UPPER UWCHLAN TOWNSHIP
PLANNING COMMISSION
AGENDA

**April 11, 2024
6:00 p.m. Workshop, 7:00 p.m. Meeting**

PRELIMINARY LAND DEVELOPMENT PLAN EAGLE ANIMAL HOSPITAL

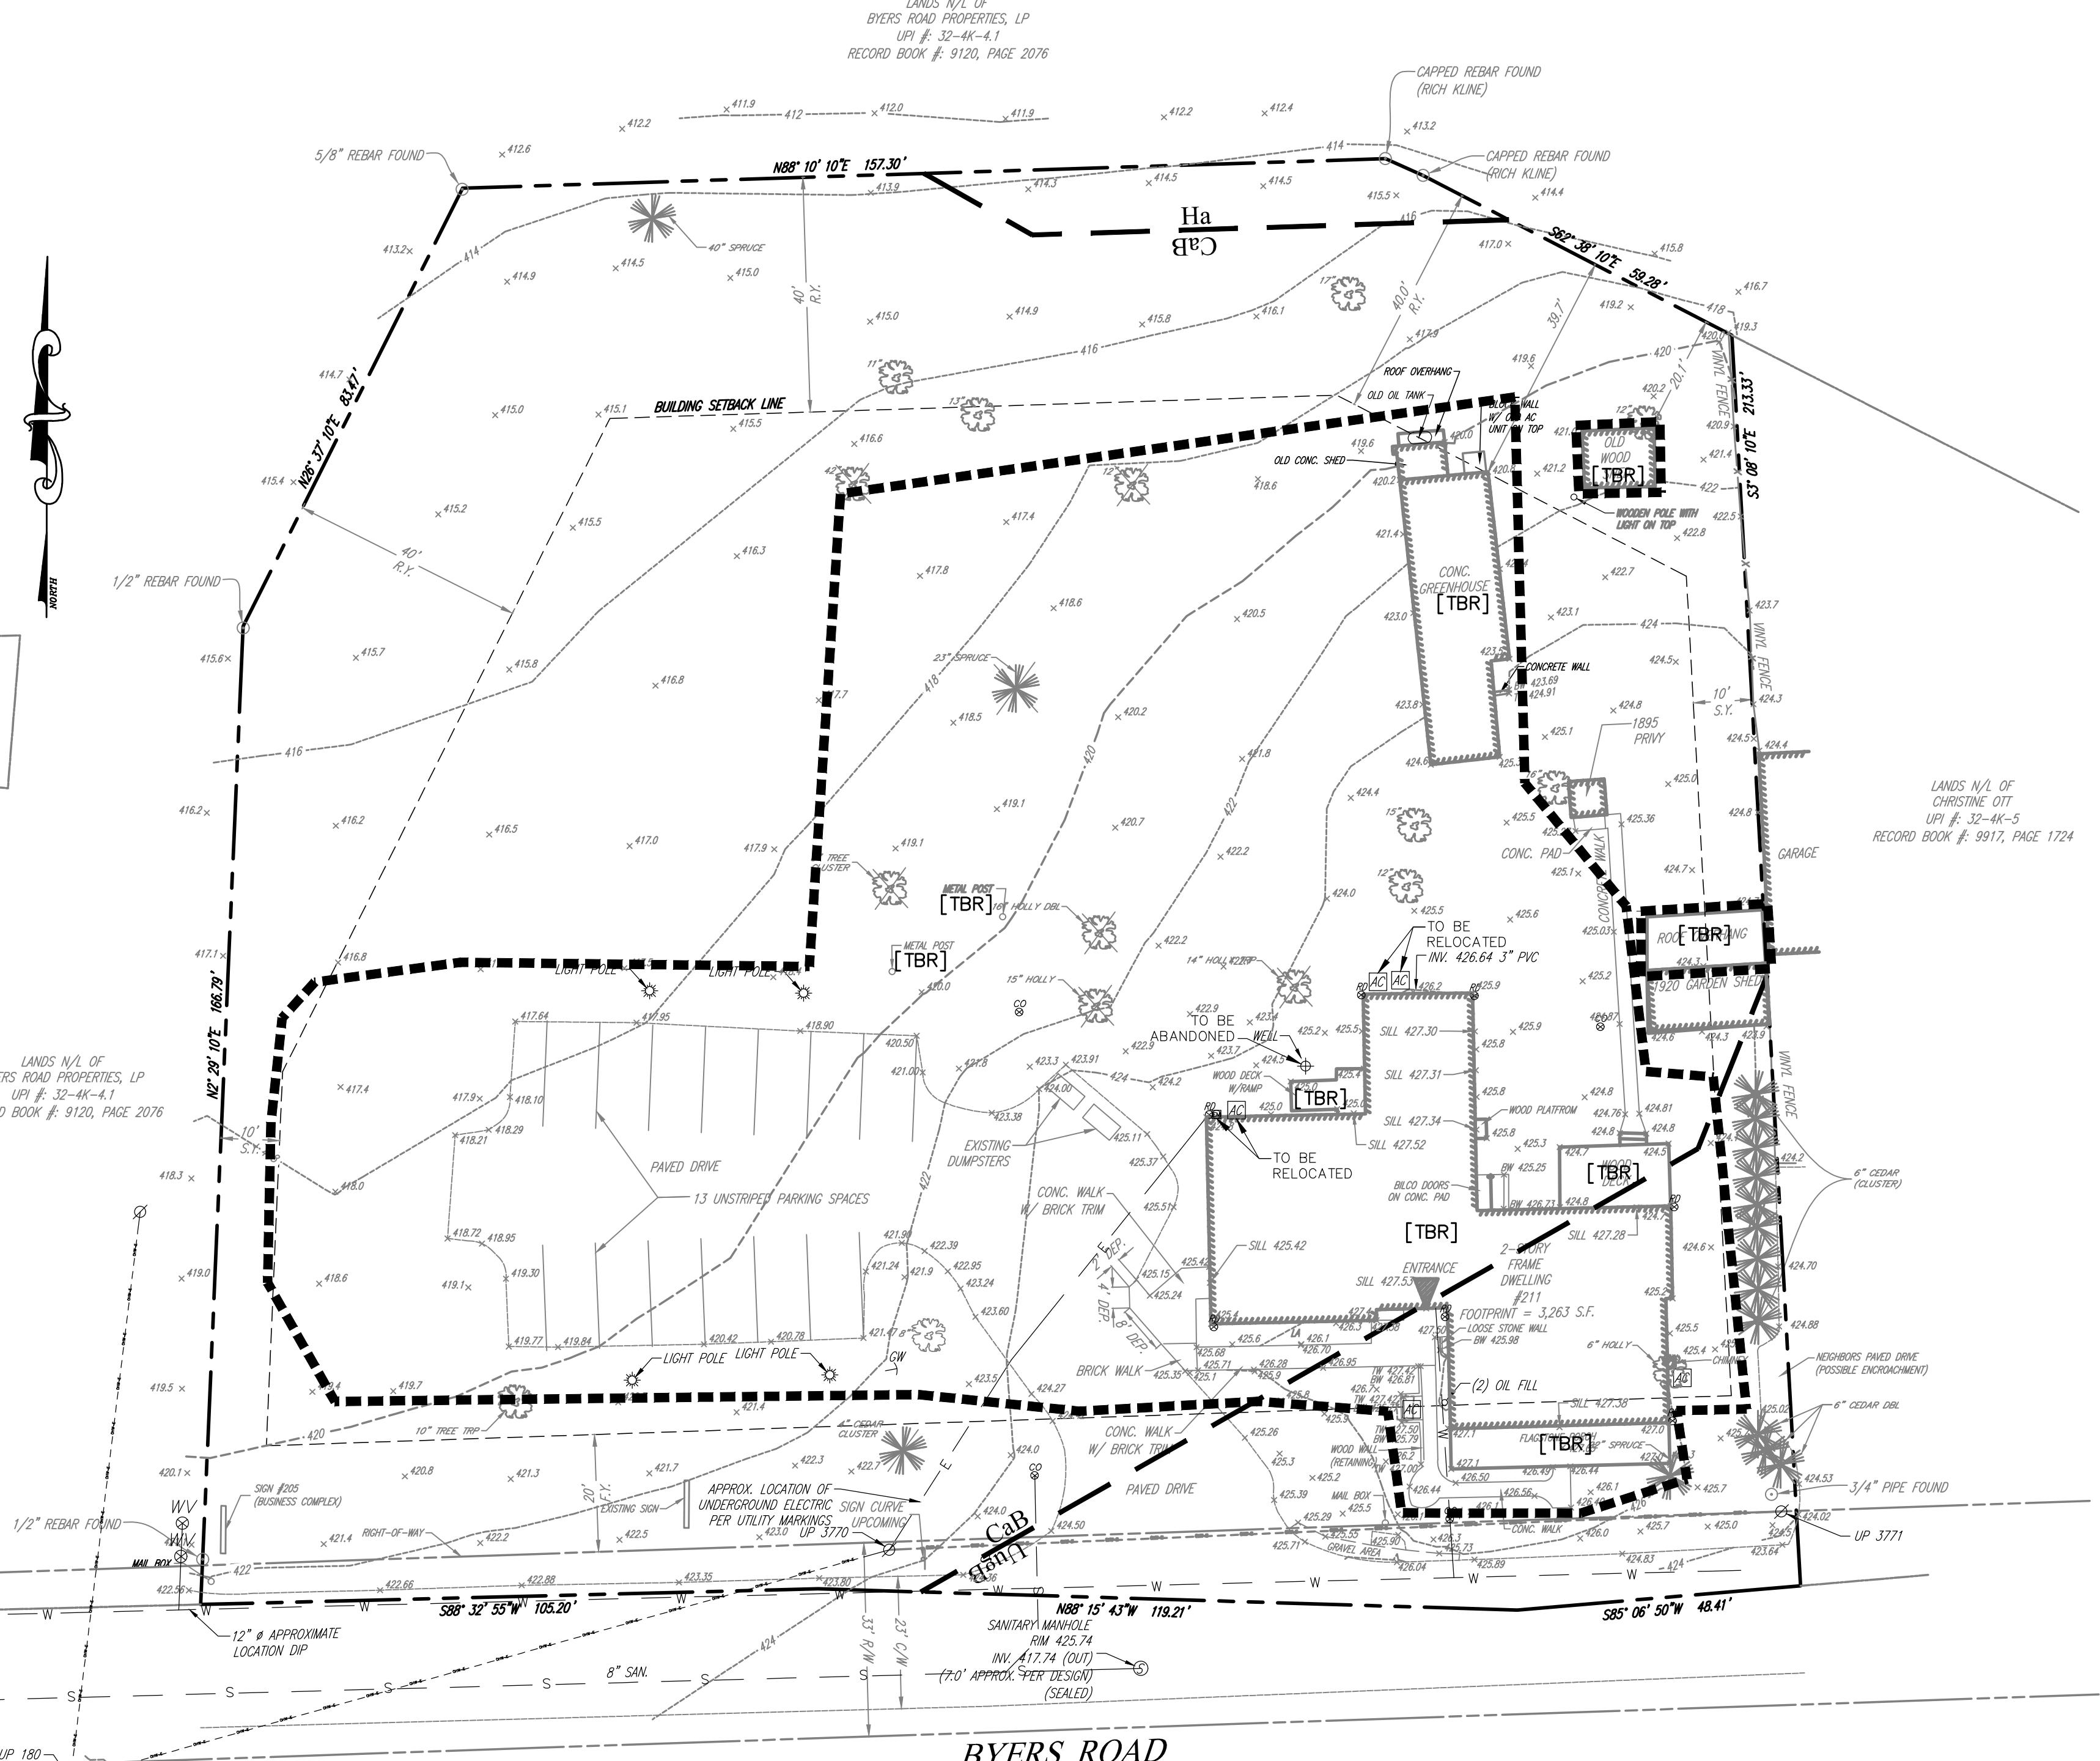
1. The site was previously an animal hospital. Plans proposed the demolition of the existing structures for the construction of the new building (5,334 square foot (SF)) and parking lot. 241 gallon per day (GPD) of capacity has already been purchased for the connection into the Byer Road Sanitary Sewer Main Extension. This capacity appears acceptable, but we recommend that the Township reserve the right to evaluate water usage after the building is opened and require the purchase of additional capacity, if warranted. The required sanitary sewer capacity will need to be clearly shown on Sheet 1 of the plan.
